BERKELEY COUNTY PUBLIC SERVICE SEWER DISTRICT BERKELEY COUNTY, WEST VIRGINIA

CONTRACT #10 – OPEQUON HEDGESVILLE WWTP UPGRADES

ADDENDUM #2

THRASHER PROJECT NO. 020-10042

SHEET No.
7A

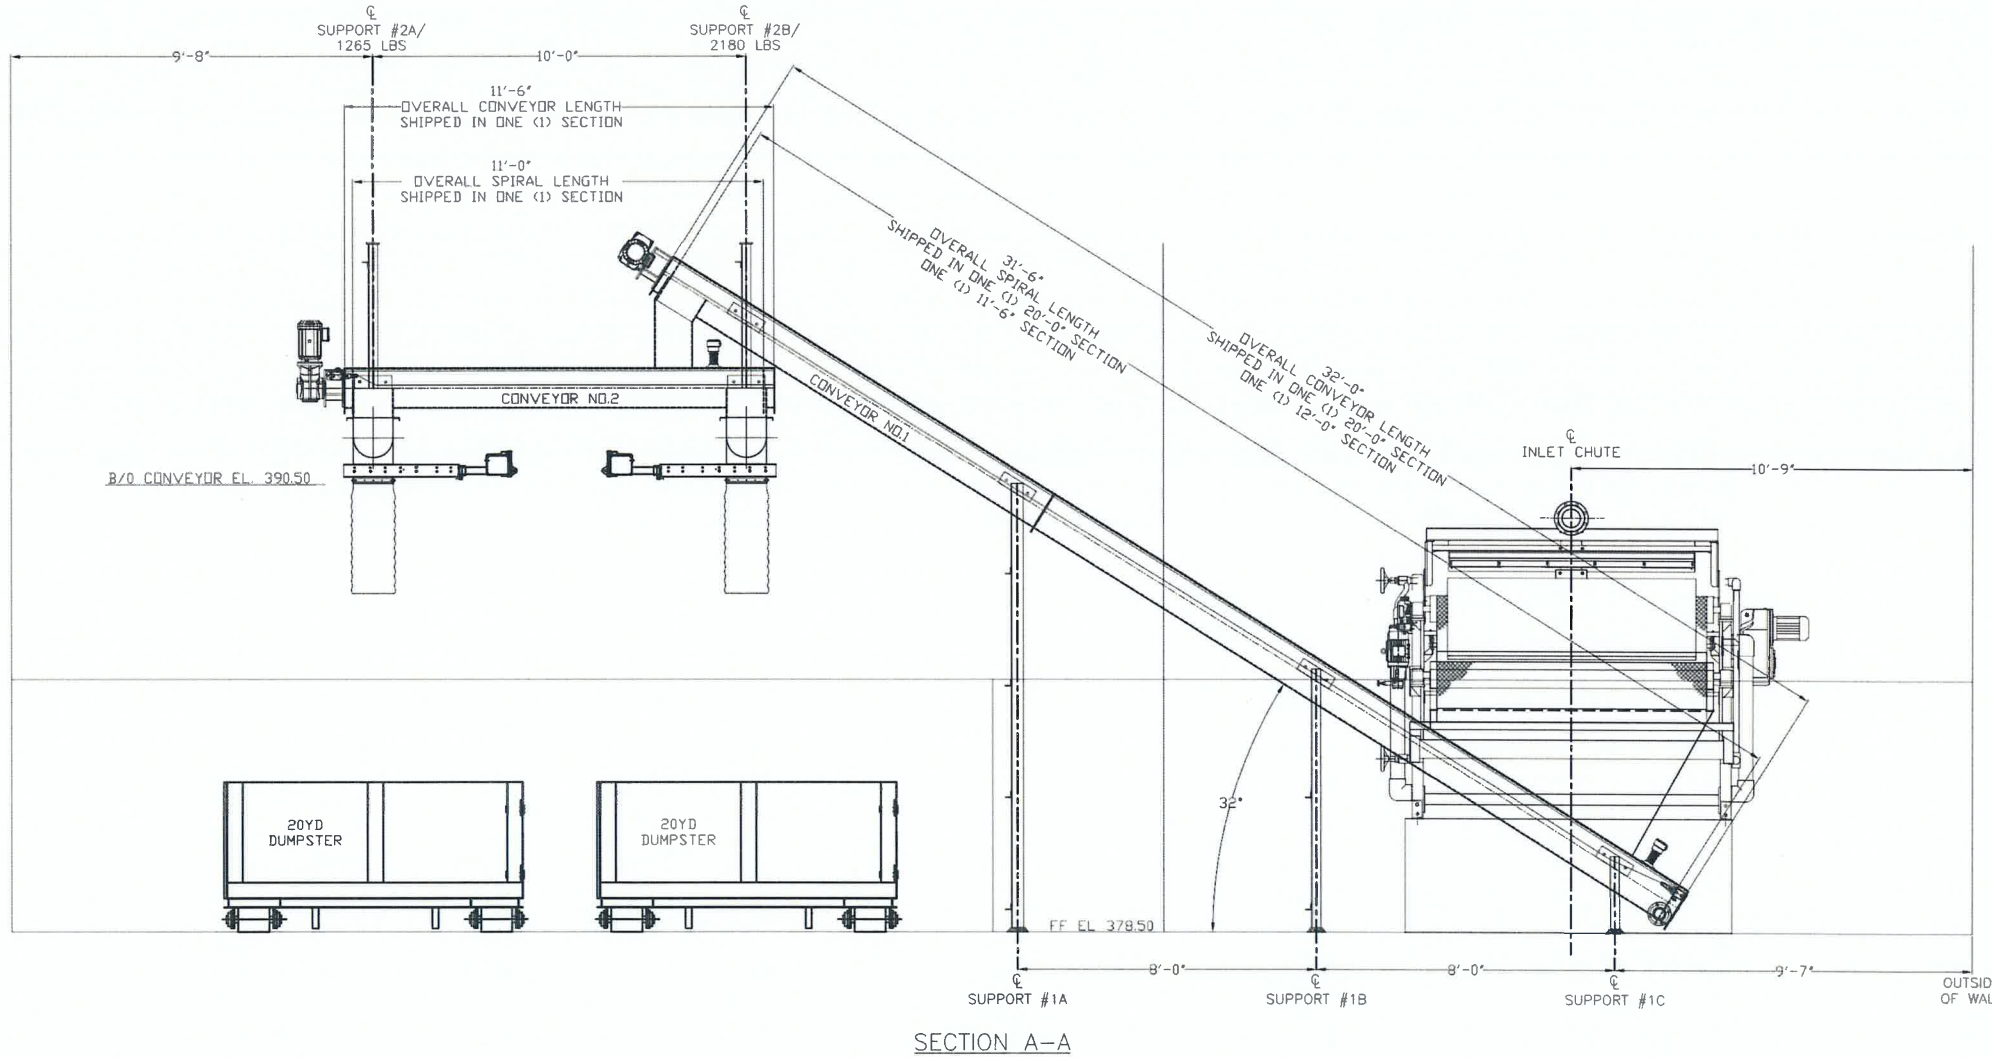
10. What are the weights of the new conveyors to be utilized?

Conveyor No.1 is 3,000 LBS and conveyor No.2 is 1,300 LBS. Conveyors No. 3 and 4 are 2,125 LBS each. Refer to Sheets 7A and 7B for the conveyor details.

BERKELEY COUNTY P.S.S.D.
UPGRADES TO OPEQUON-HEDGESVILLE
WASTEWATER TREATMENT PLANT
BERKELEY COUNTY, WEST VIRGINIA
CONVEYOR DETAILS

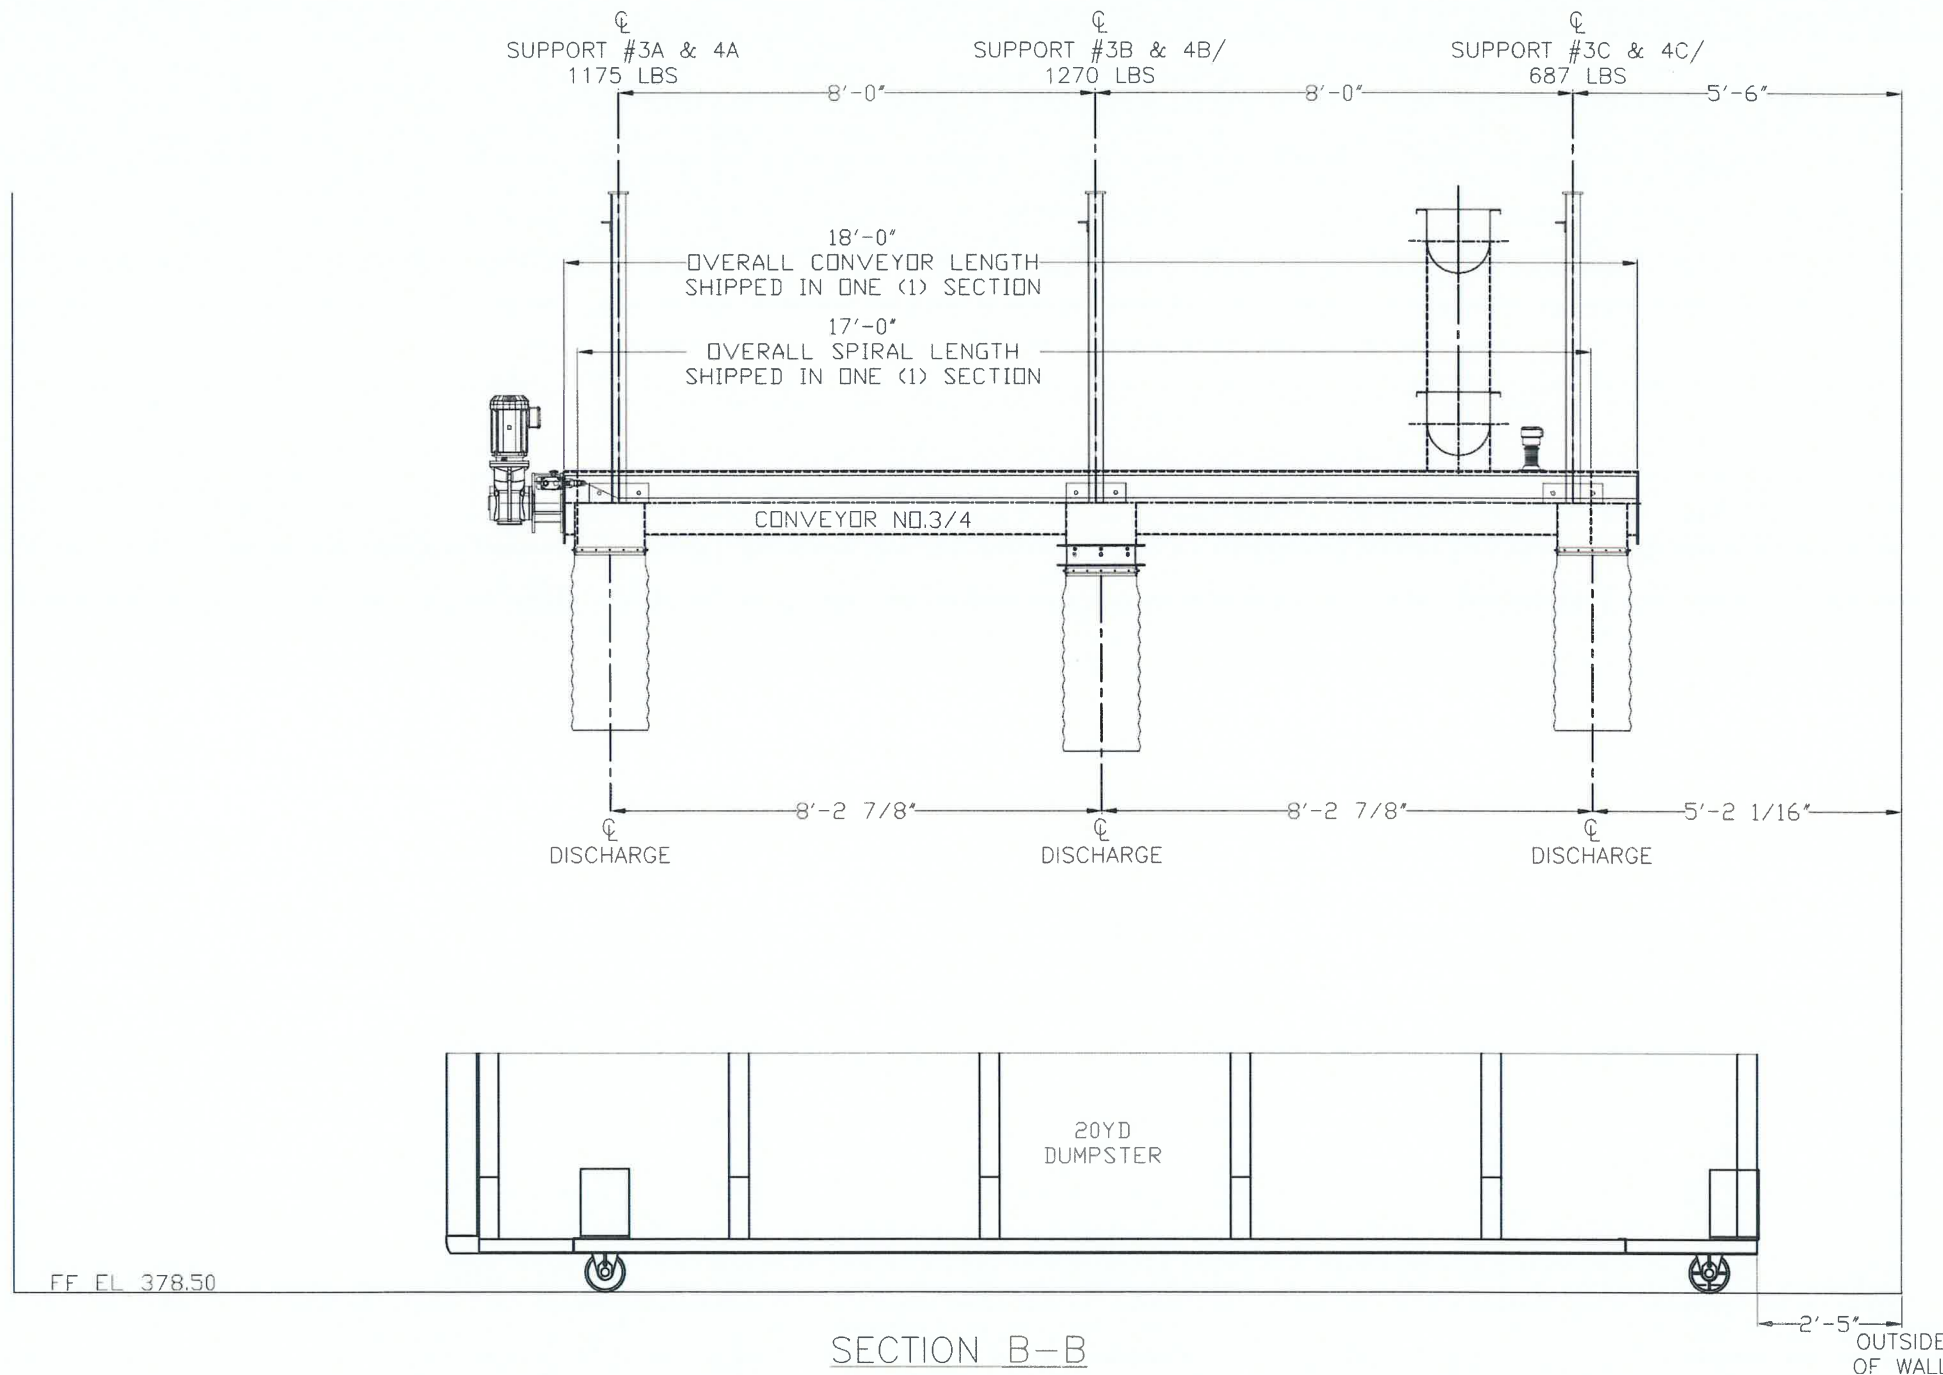
36. Drawing #7 - Can a detail be provided for the structural steel required to support the two conveyors?

Reference Spec section 133419 – Delegated-Design Submittal: Include analysis data indicating compliance performance requirements and design data sheet and sealed by the qualified professional engineer responsible for their preparation. The Thrasher Group will comply with the judgement of the delegated professional engineer given compliance with Spec Section 133419 and the structural loads provided on Sheet #7A and Sheet #7B.

SHEET No.
9

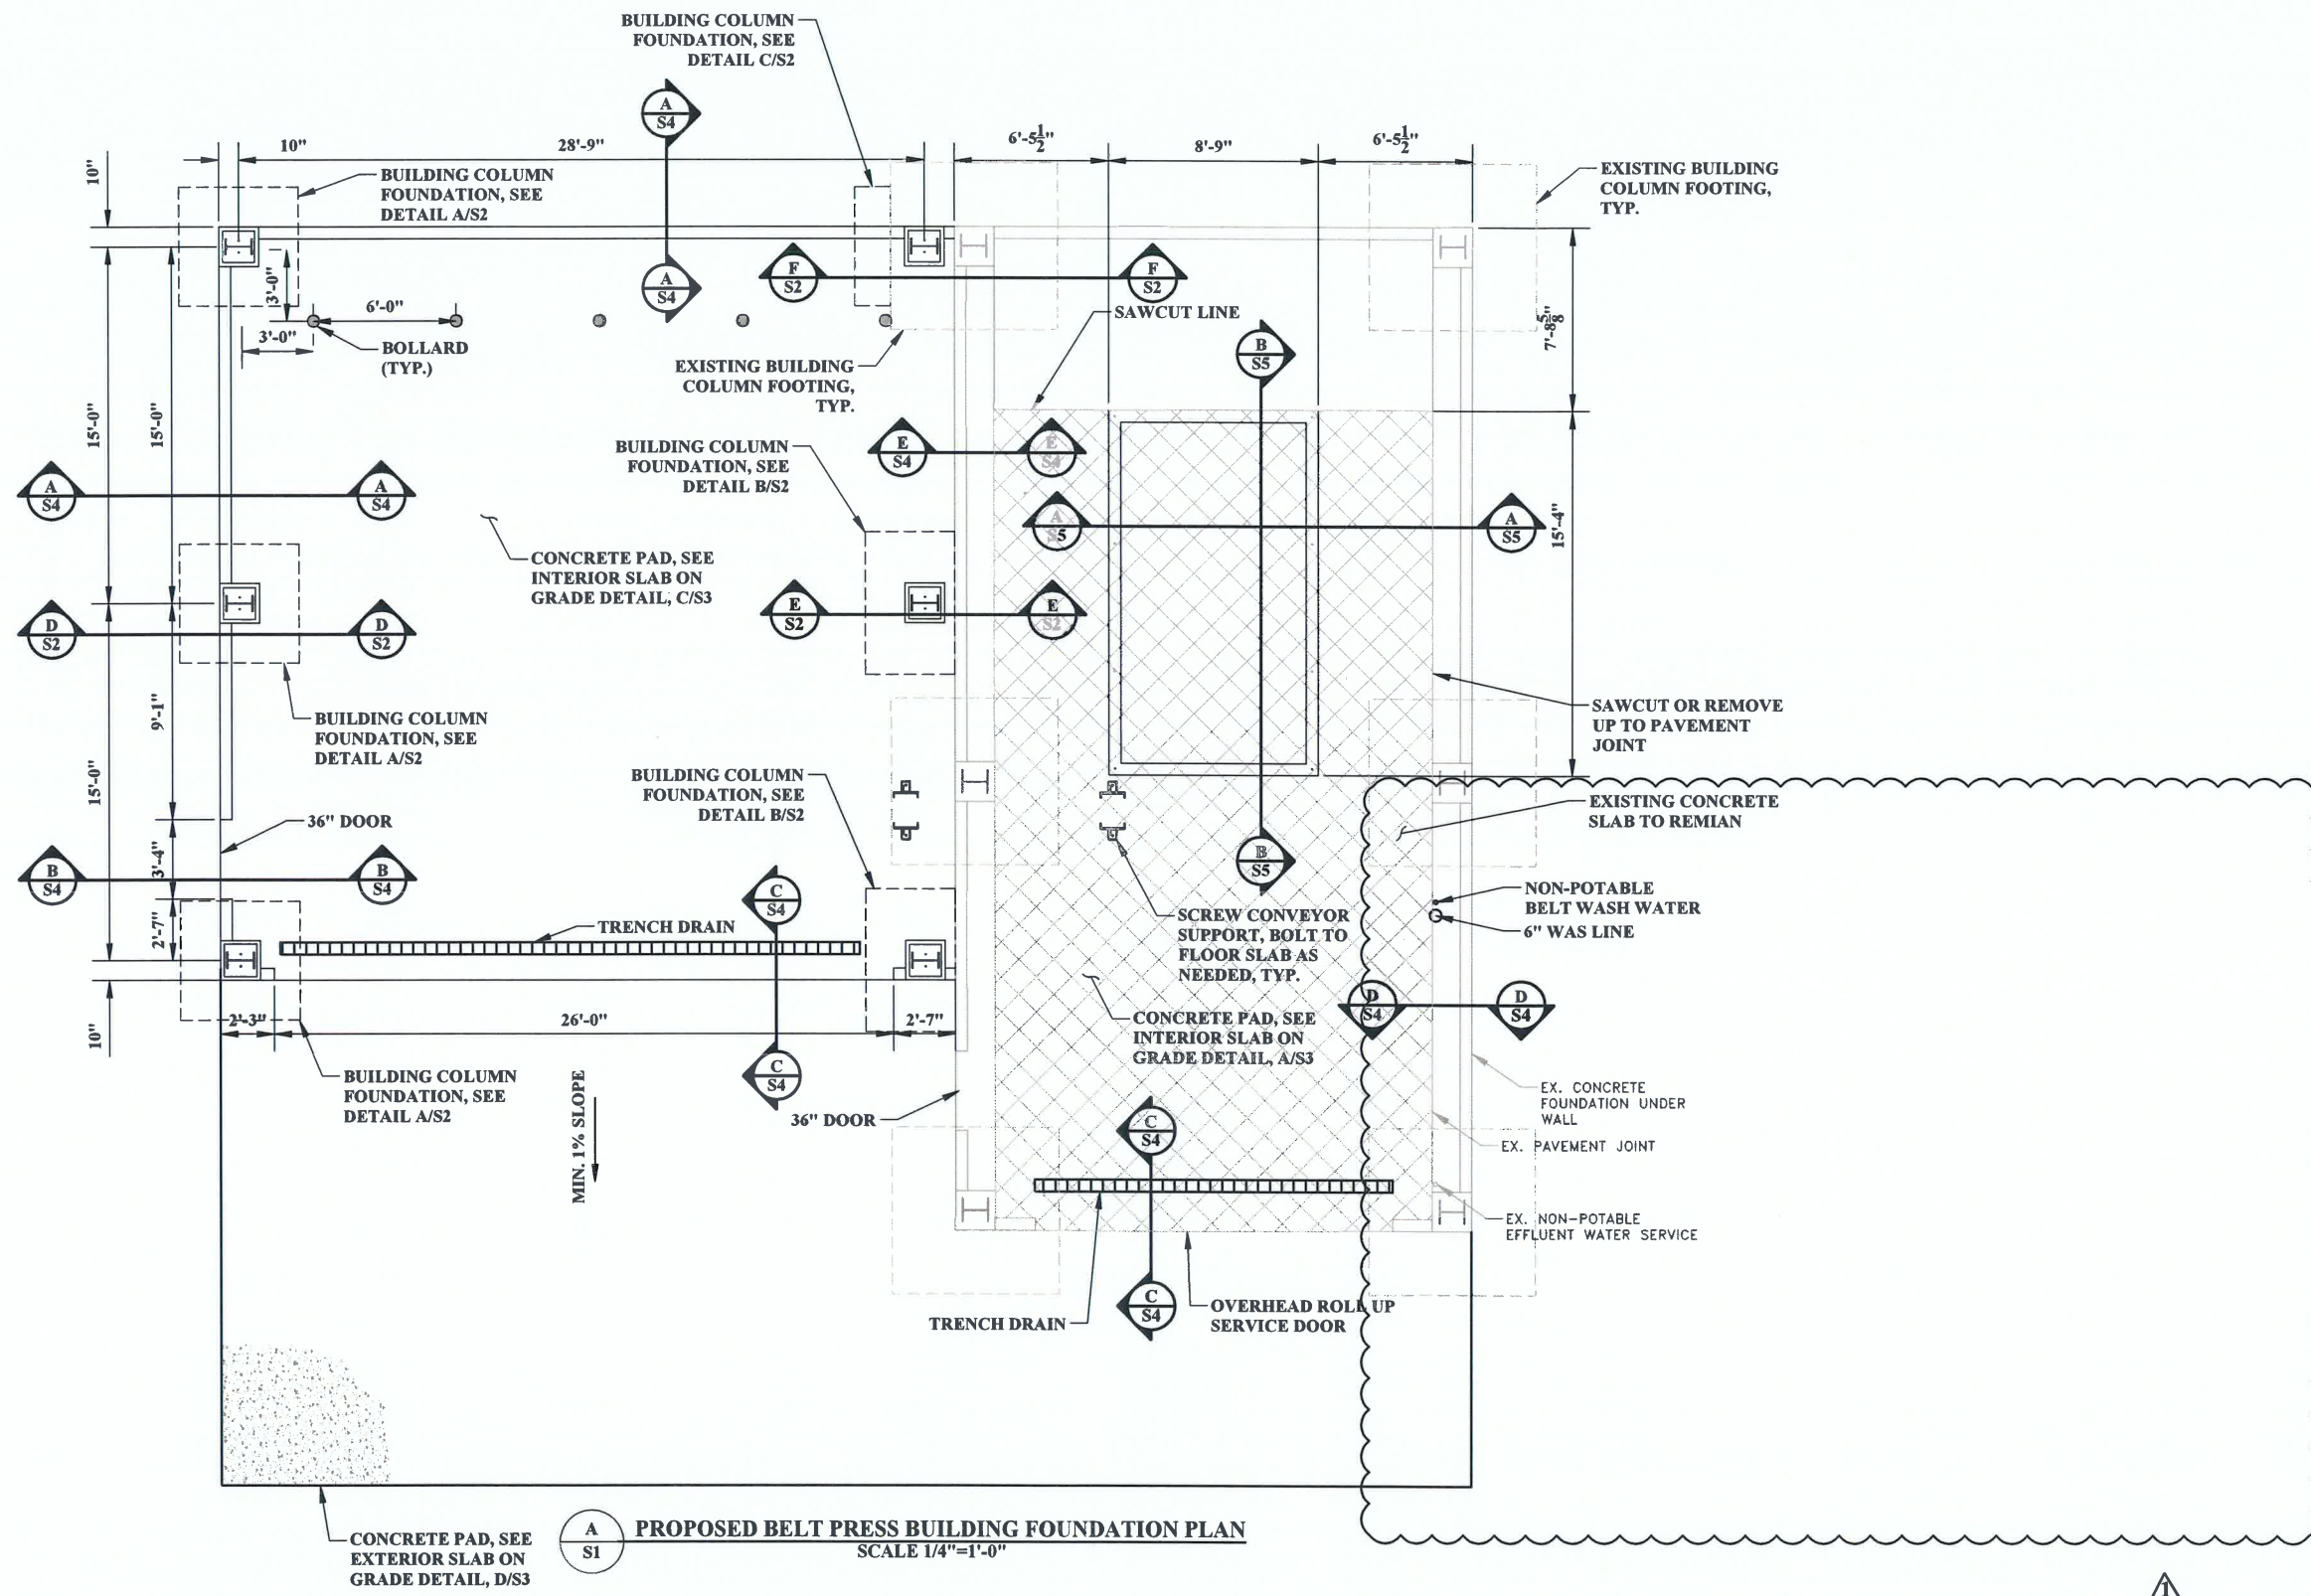
29. Press Building – Referencing Sheet #9, What is the requirement for doors (D1-D4)? Would FRP doors be considered?

Press Building - Doors D1-D4 are to be insulated aluminum doors, they are not to be substituted for FRP doors.

SHEET No.	D6
-----------	----

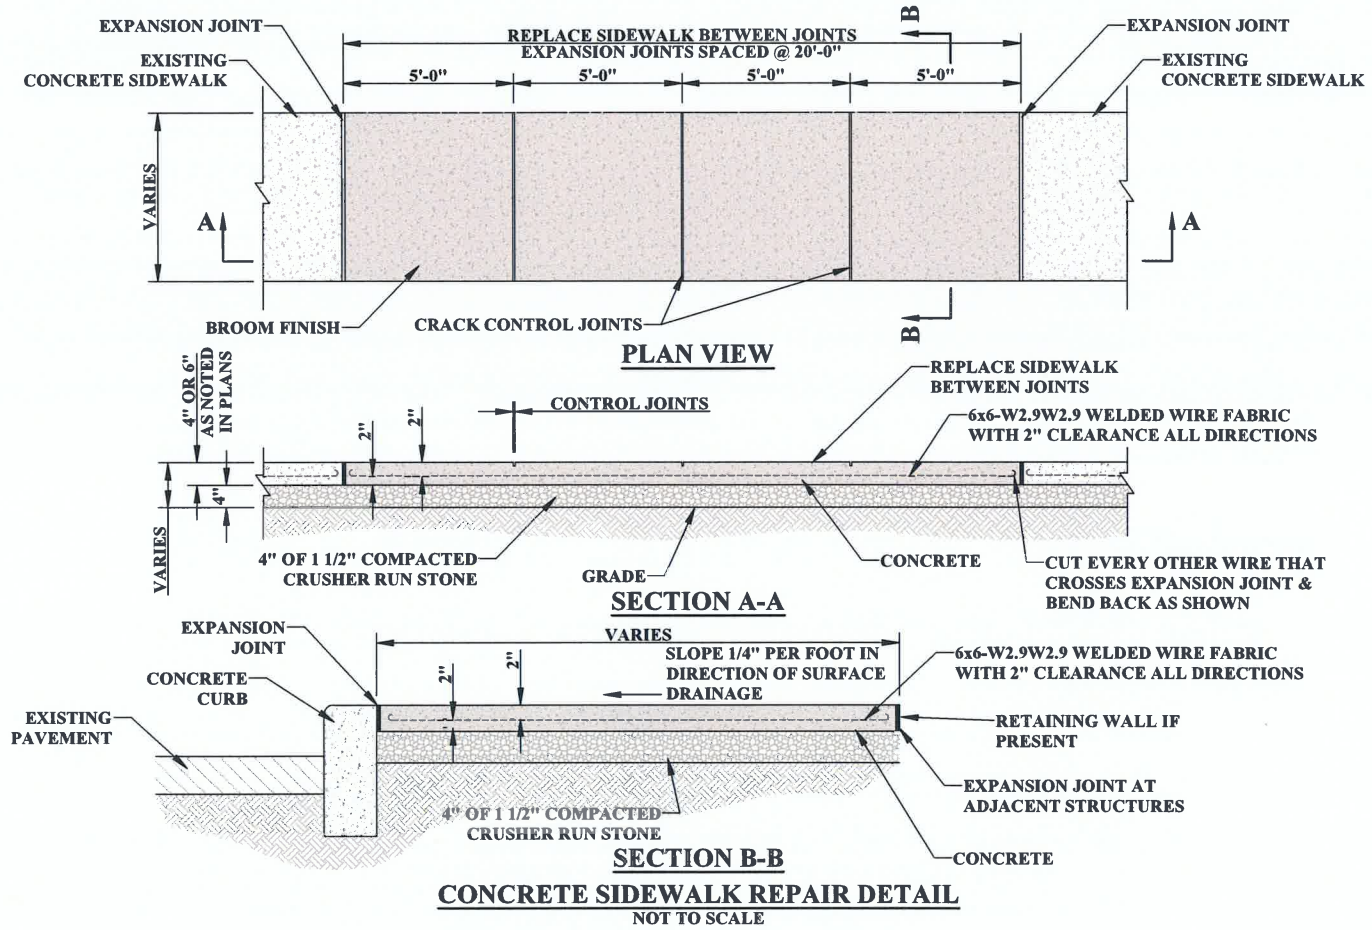
41. Drawing #3 – Will a new concrete pad be required once the new valves are installed? Can a detail be provided?

Yes. Refer to Sheet D6 included with this Addendum #1 for the detail.
